Type <b>Coffee Vending Machine</b>	Model <b>OPERA TOUCH</b>	N° T.I. <b>05_2023</b>
Serial Number <b>31921663</b>	Subject <b>CPU BOARD MODIFICATION</b>

**REASON:**

*Wi-Fi and Bluetooth chip available again*

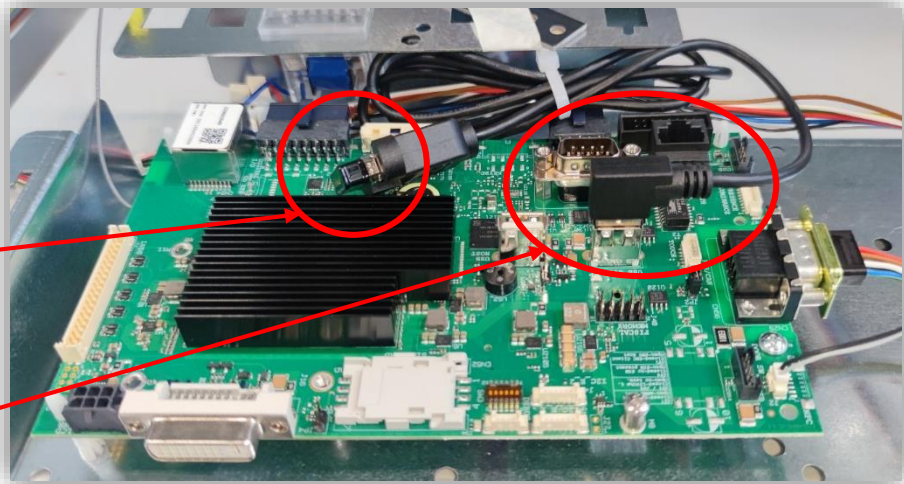
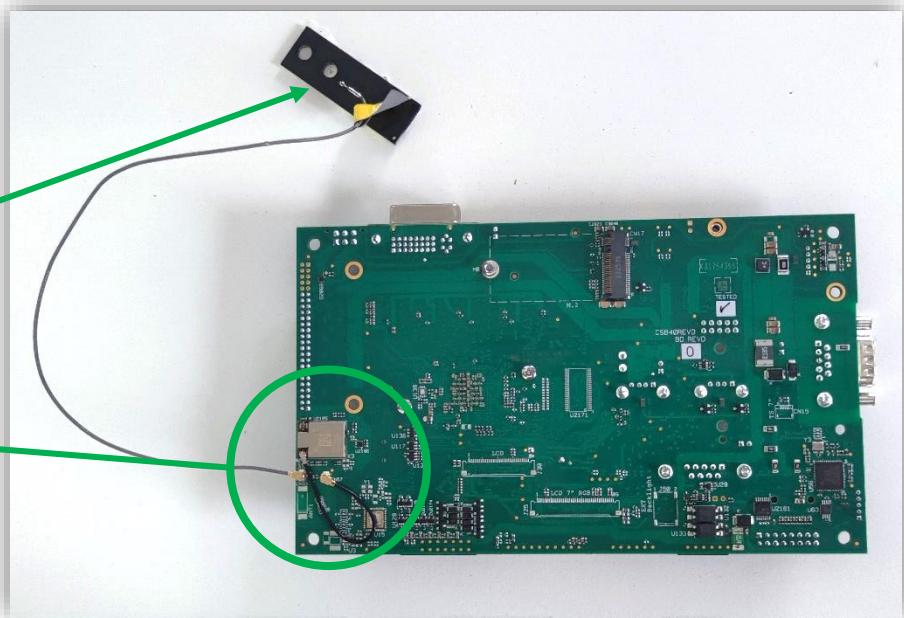
Introduction of a new CPU board with integrated *Wi-Fi and Bluetooth* chip

**Pre – modification** CPU board (no Wi-Fi /BT chip) with Dongle and Extension

**New** CPU board  
(with Wi-Fi / BT chip)  
Spare code: **266090**

**Wi-Fi / Bluetooth chip**

For machines prior to above S/Ns, if it is necessary to replace the CPU board, the **new** CPU board must be used, spare code **266090**.

The **new** CPU board can run only with the SW *Application Key 2* below:

➤ Opera Touch: **Key 2** rev. **1.12.23** or later.

These SW *Application Key 2* versions are also compatible with the **pre – modification** CPU board, spare code **265669**. Therefore, if you want to update the machines SW, without replacing the CPU board, (keeping the **pre - modification** CPU in the machine) you can do it without any additional action.
